HYUNDAI
Technical Service Bulletin

| GROUP RECALL | NUMBER 24-01-027H-9 |

SUBJECT: ANTI-LOCK BRAKING SYSTEM (ABS) FUSE REPLACEMENT
 (RECALL 251)

This TSB supersedes TSB#24-01-027H-8 to revise the starting production date ranges for Tucson (LM) and Veracruz (EN) models.

Multi-Fuse Table:

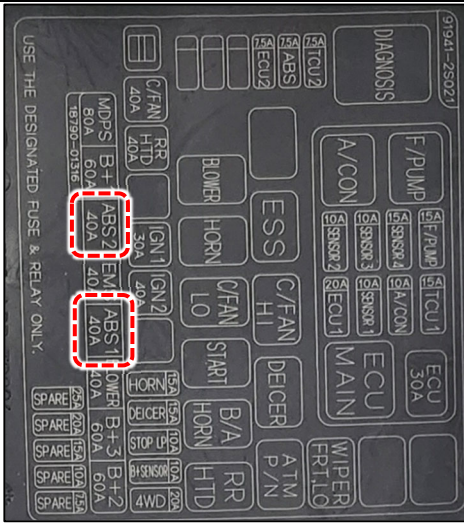
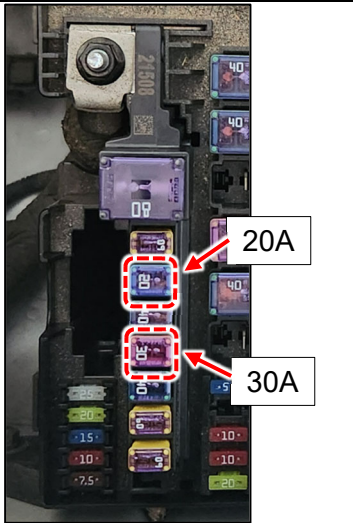
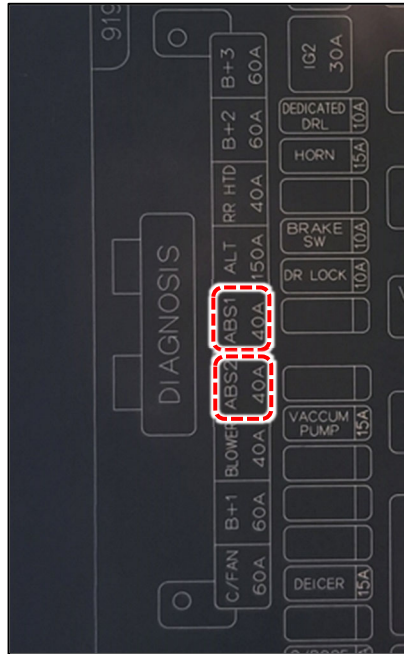
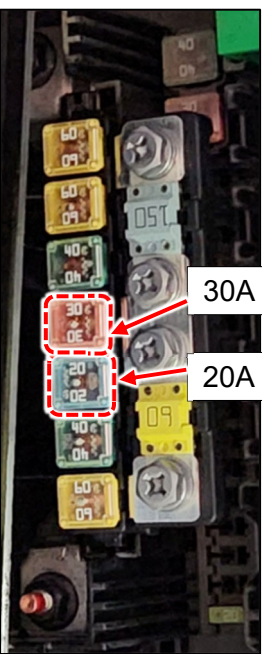
| Model | Fuse Changes | Images |
|----------------------------|--|--|
| <p>Santa Fe Sport (AN)</p> | <p>ABS1: 40A → 30A ABS2: 40A → 30A</p> |  |
| <p>Santa Fe (NC)</p> | <p>ABS1: 40A → 30A ABS2: 40A → 30A</p> |  |
| <p>Accent (RB)</p> | <p>ABS1: 40A → 30A ABS2: 40A → 20A</p> |  |
| <p>Tucson (LM)</p> | <p>ABS1: 40A → 30A ABS2: 40A → 20A</p> |  |  |
| <p>Genesis Coupe (BK)</p> | <p>ABS1: 40A → 30A ABS2: 40A → 20A</p> |  |  |

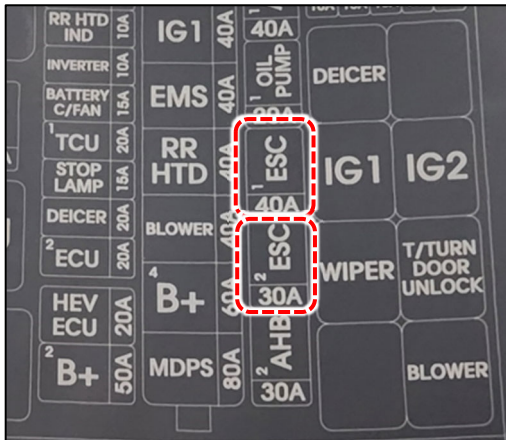
- Locate the ABS1/ESC1 and ABS2/ESC2 fuses. Remove the two fuses.

- Install the two new single fuses as shown.

ESC1 position (40A fuse originally)
Install new 30A fuse (pink).

ESC2 position (30A fuse originally):
Install 20A fuse (blue).

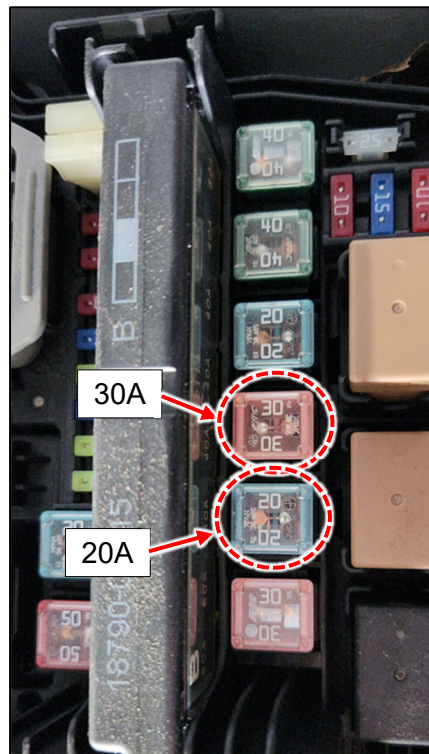
Fuse values shown are for Sonata Hybrid (YF HEV). Refer to the Single Fuse Table for the specific model fuse locations and values.

Single & Multi-Fuse Table:

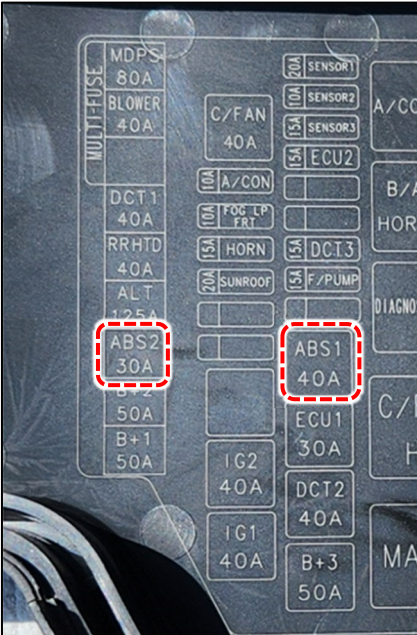
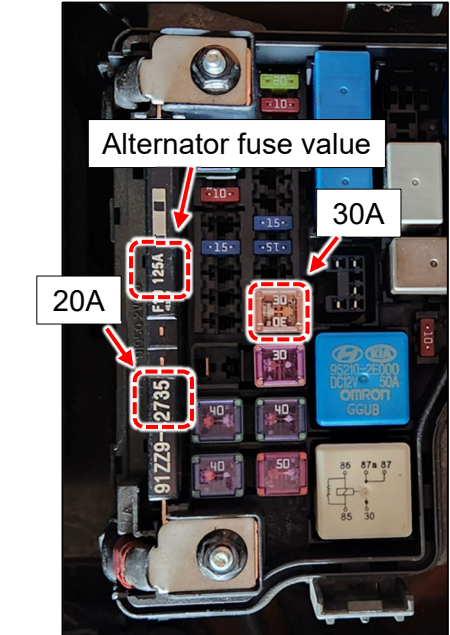
| Model | Fuse Changes | Images |
|--------------------------------------|------------------------------------|--|
| Azera (HG) | ESC1: 40A → 30A ESC2: 40A → 20A |  |
| Elantra (MD/UD) & Elantra Coupe (JK) | ABS1: 40A → 30A ABS2: 30A → 20A |  |
| <p>Veloster (FS)</p> | <p>ABS1: 40A → 30A ABS2: 30A → 20A</p> <p>Veloster Turbo uses a 150A alternator fuse</p> <p>Veloster Non-turbo uses a 125A alternator fuse</p> <p>The multi-fuse is labeled with the alternator fuse value</p> |  |  |

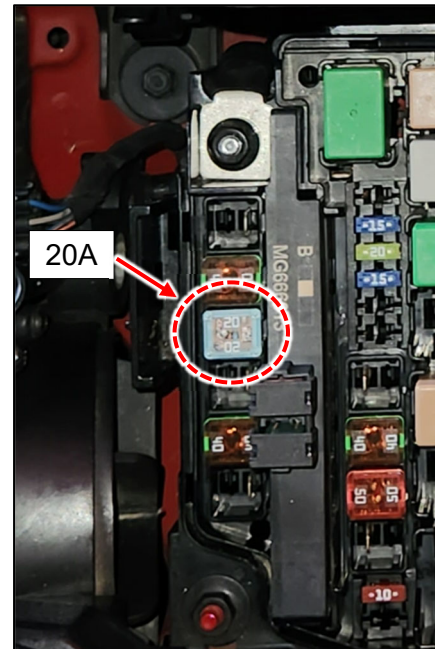
5. Install the new single fuse as shown.

For Elantra (MD/UD), Elantra Coupe (JK), and Azera (HG) vehicles:
 ABS2/ESC2 position (30A fuse originally):
 Install 20A fuse (blue).

For Veloster (FS) vehicles:
 ABS1 position (40A fuse originally):
 Install 30A fuse (pink).

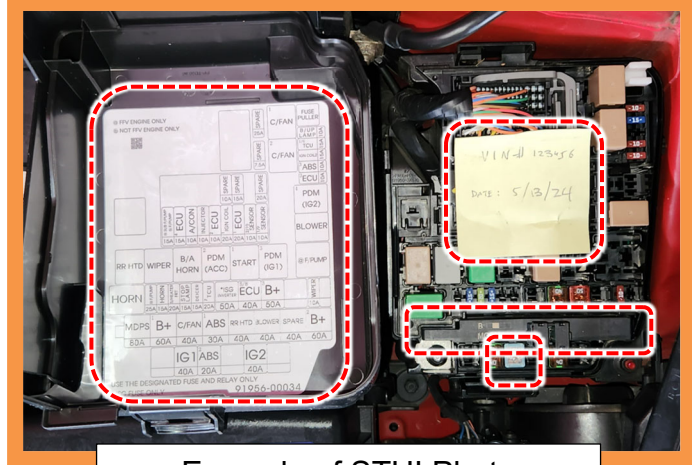
Fuse label shown is for Elantra Coupe (JK). Refer to the Single & Multi-Fuse Table for the specific model fuse value changes.

For Veloster (FS) ABS2 fuse location, the supplied 20A label may slightly exceed the boundary printed on the original fuse cover.
